Climax closure cost model

We have reviewed your version of the Climax closure costs and offer some brief explanations which may shed some light on our approaches and derivations of certain unit rates in our estimate. In so doing, we have added comments (listed as 15 "notes") to our Reclamation Cost Estimate narrative and cross-referenced these to your cost comparison spreadsheet.

Climax Molybdenum Company – Climax Mine, CO
Permit M-1977-493
2016 Reclamation Cost Estimate Update
(revised August 2018)
(partial revision December 2018)

CLIMAX SITE
RECLAMATION PLAN

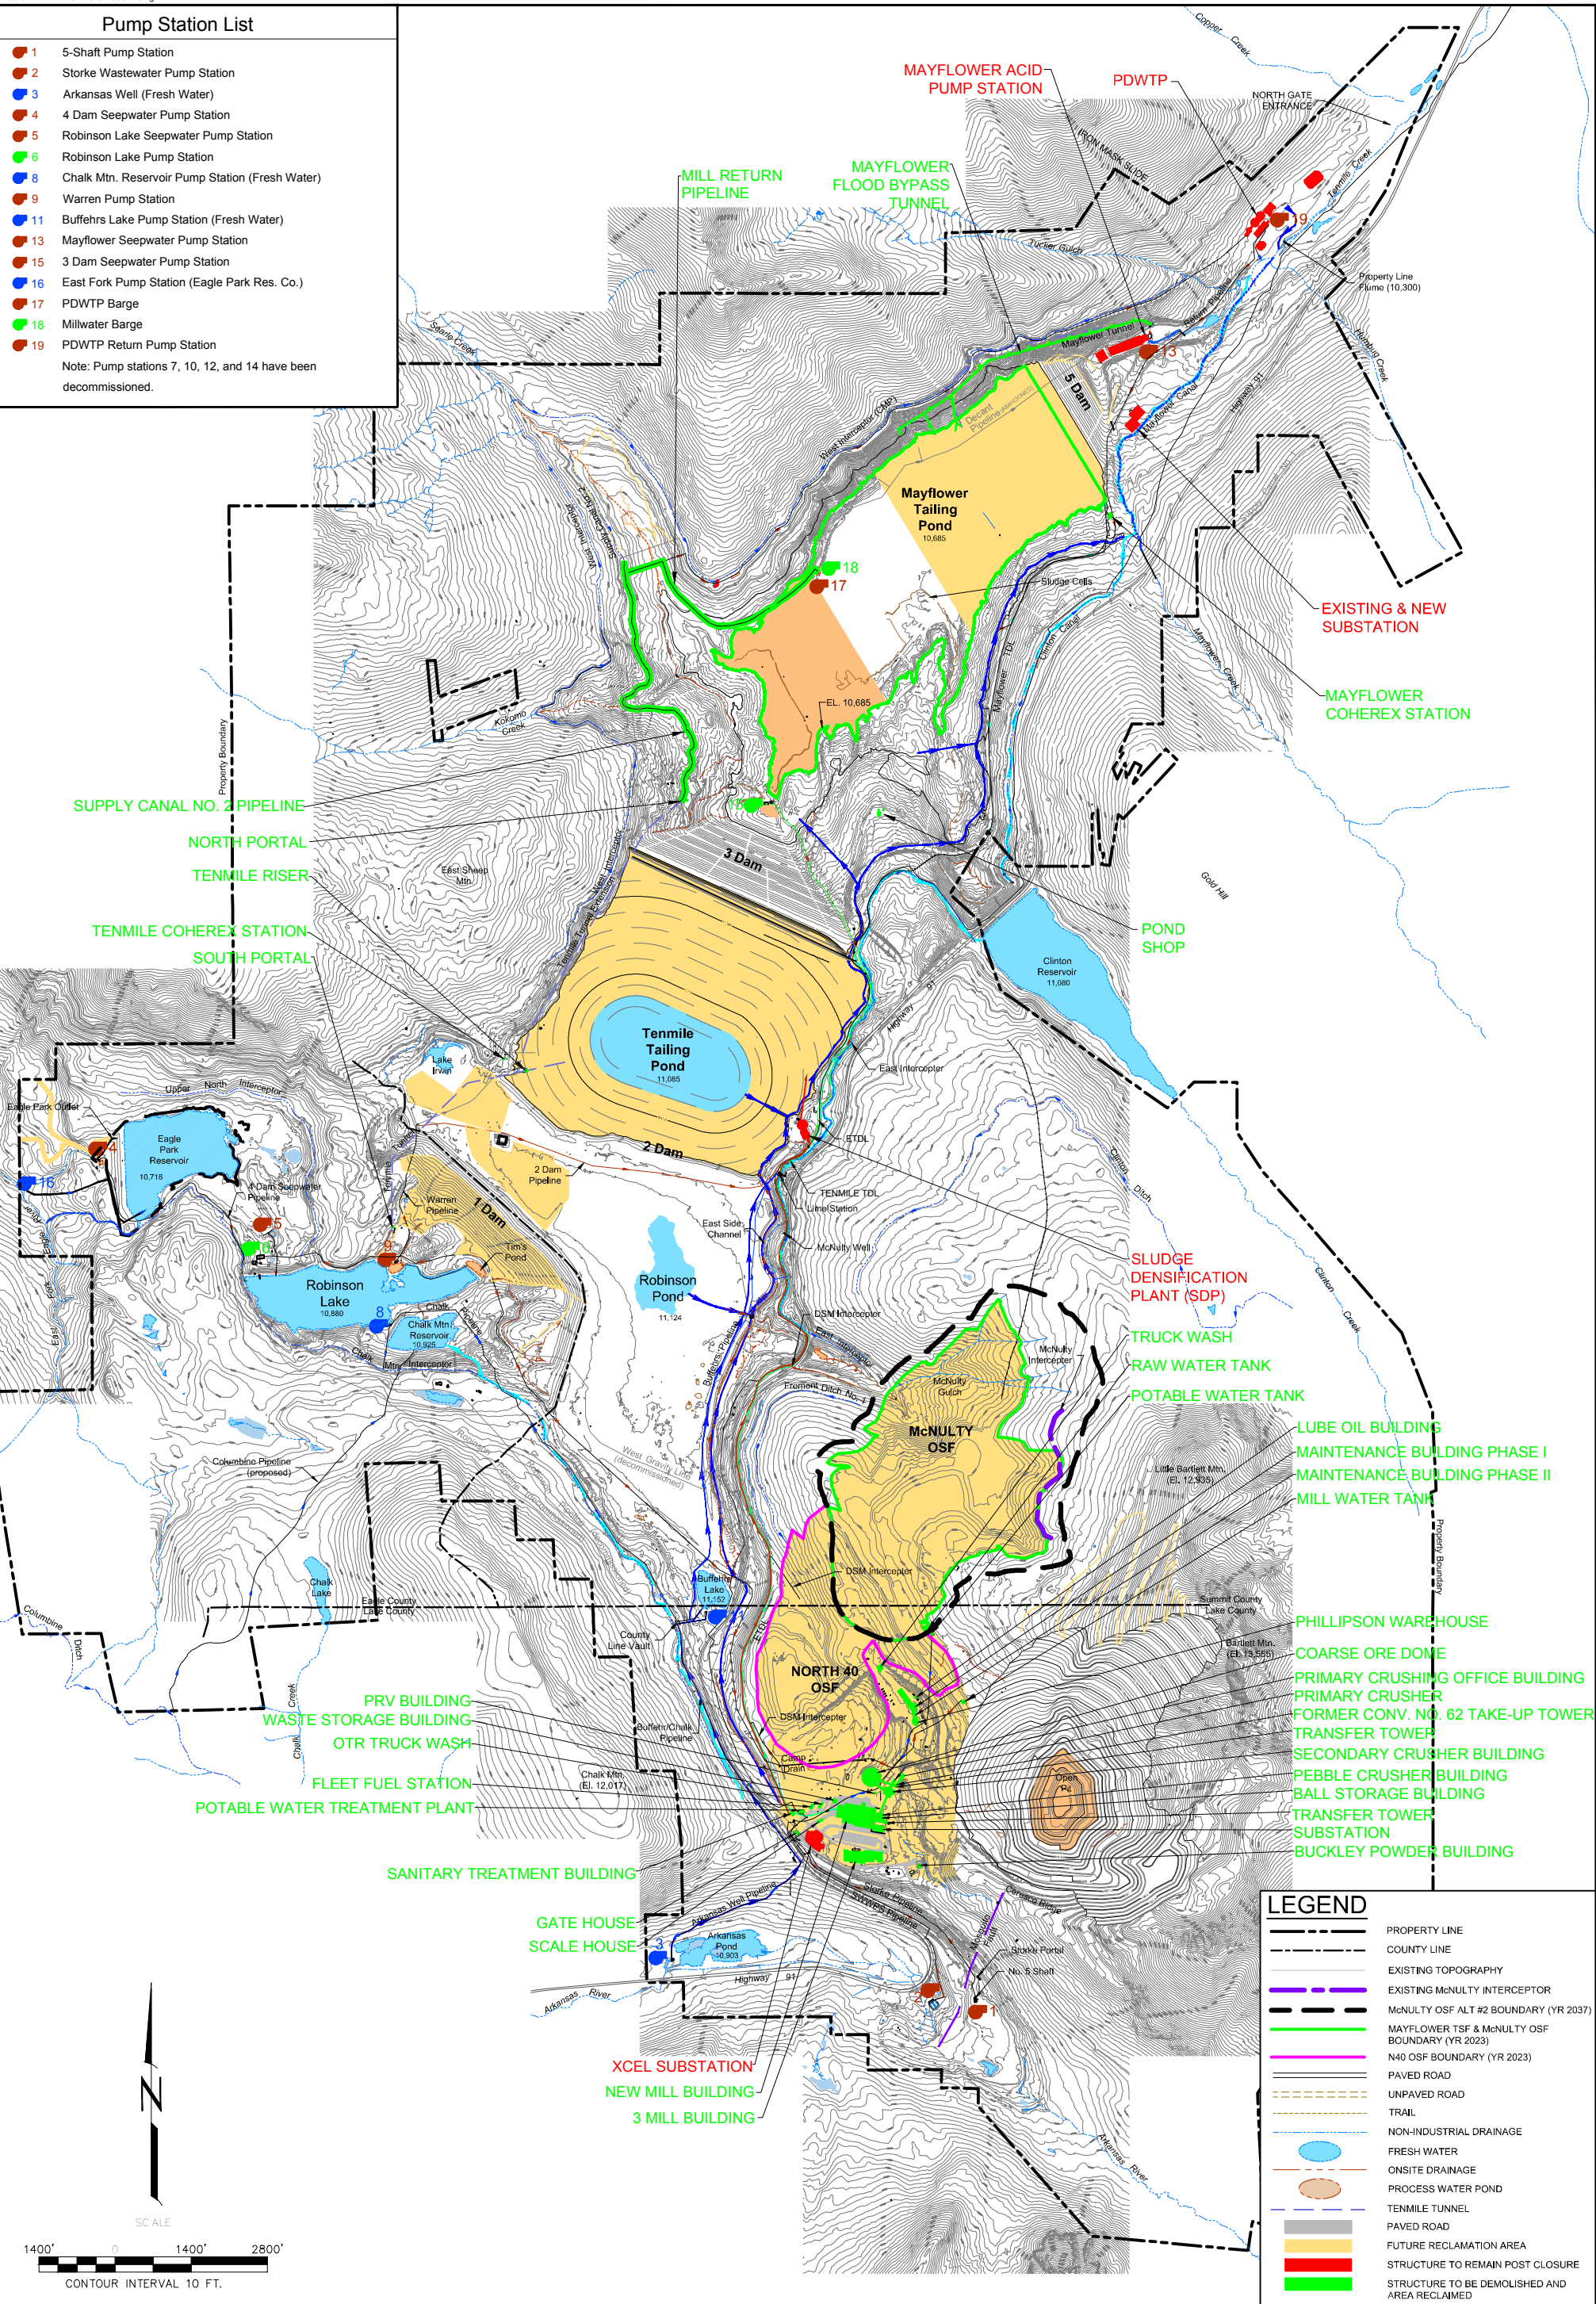
As discussed with you during a couple of recent phone calls, we have decided that we would like to pursue a closure cost which extends through the next 5 years of operation (end of 2023), for which the site's reclamation maps have been modified and are attached. The corresponding closure costs for this interim mine plan approach to closure cost estimating are not being provided at this time, however, since they will depend on your approval of this approach and all 15 discussion items included herein.
